Project: Chagrin Falls Police & Fire Renovations

Project #:2018020653

We submit the following clarifications, revisions, and comments for your review and approval. Comments are organized per Correction Letter No. 2 from Anthony Jacques, dated February 6, 2019, and they are reproduced below for reference. Responses are in bold italics. Clarifications made to the drawing set in response to these comments have been clouded as Revision #3. Please call if you have any questions or concerns.

DOOR SCHEDULE, **ELEVATIONS** & DETAILS

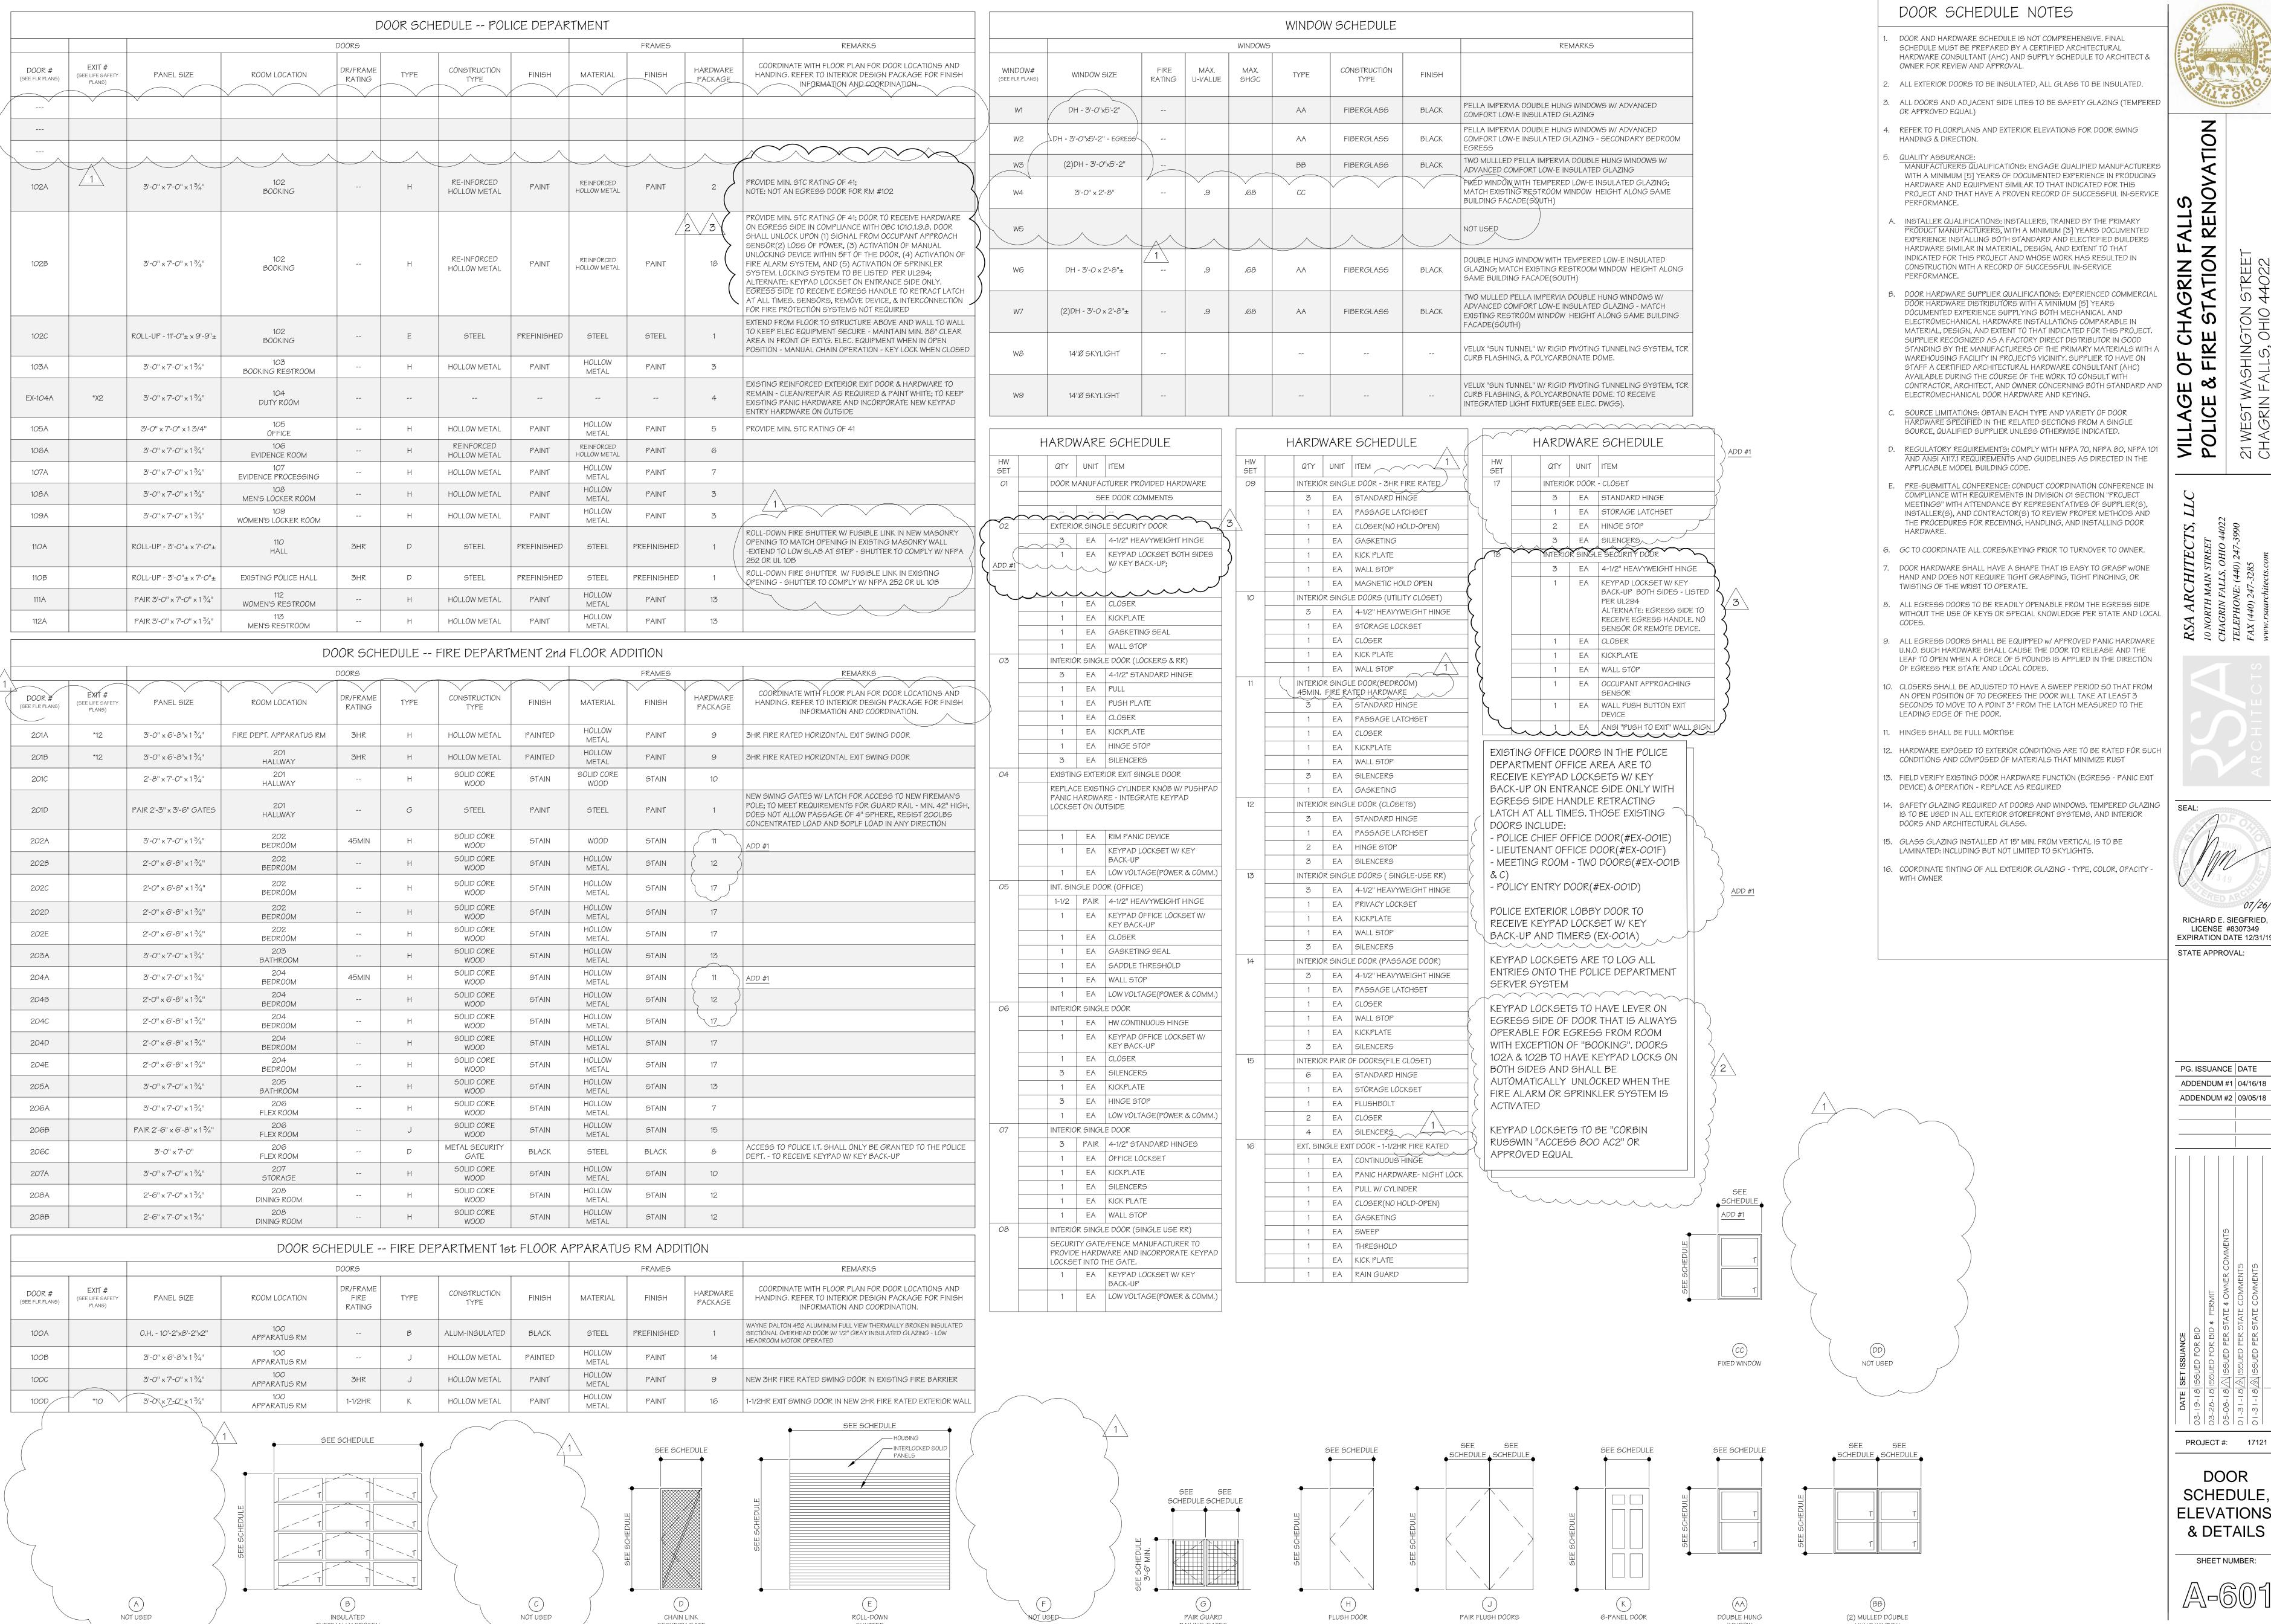
4) The documents still show sensor release devises on the egress side of egress doors. Sensor release devices (card readers, key pads, magnetic locks, elec. strikes, etc.) are allowed on egress doors in use group or occupancy A, B, E, 1-1,1-2,1-4, M, R-l and R-2 where they meet all six items in OBC 1010.1.9.8. I-3 use groups do not allow these devices. Submit revised documents showing compliance.

Keypad electric lock hardware for Door #102B has been revised to show compliance with the six items listed under OBC 1010.1.9.8. Refer to door #102B on the door schedule and hardware set #18 in the hardware schedule on sheet "A601". The hardware shall automatically unlock when (1) a sensor installed on egress side sends a signal to unlock the door when an occupant approaches the door, (2) there is a loss of power to the door, (3) a manual unlocking device is installed within 5ft of the door between 40" & 48" aff with a sign that reads "PUSH TO EXIT", (4)activation of the fire alarm system, or (5) activation of the automatic sprinkler system or fire detection system. Hardware shall be UL 294 listed.

Alternate: key pad lock set is to be installed only on entrance side of door with ANSI A117.1 compliant handle on the egress side allowing operation of the latch at all times in accordance with OBC 1010.1.10 for rooms with less then 50 occupants.
